Dun Laoghaire to City Centre

Core Bus Corridor
Stage F Road Safety Audit

14 July 2017

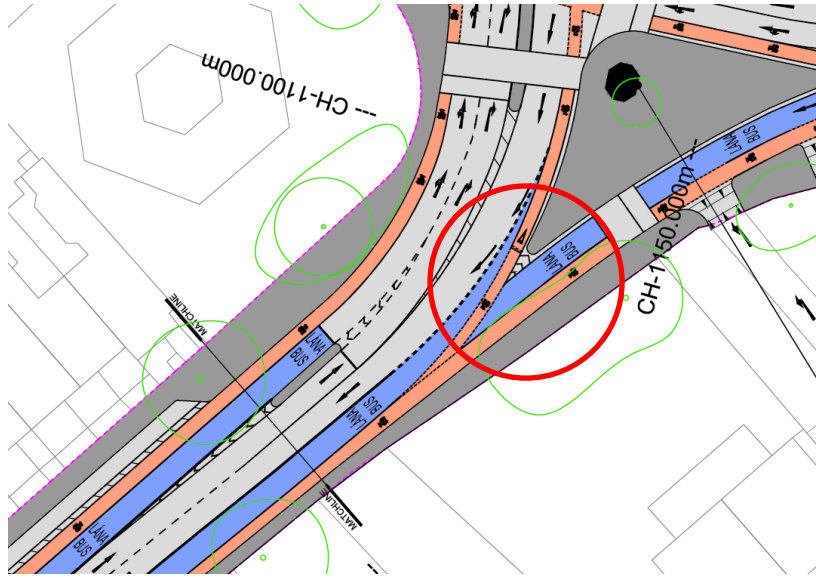
4.3.1 Problem		
Location:	Baggot Street	
Drawing:	Sheet 1 of 20	
Summary:	Removal of Existing Central Median.	
Description:		Figure 1: Existing Trees in the Central Median on Baggot Street
<p>It is proposed to remove the existing trees on Baggot Street. However, according to DMURS, the placing of street trees can have “a traffic calming effect...where trees are planted in continuous rows and their canopies overhang, at least in part, the vehicular carriageway”.</p> <p>Given the wide width of the street, the removal of the existing trees may encourage motorists to speed excessively using this route, increasing the risk of and severity of collisions.</p>		
Recommendation:		
<p>Consideration should be given to retaining the trees along the central median, to provide a traffic calming effect along this section of Baggot Street, which is part of the newly introduced 30km/h zone.</p>
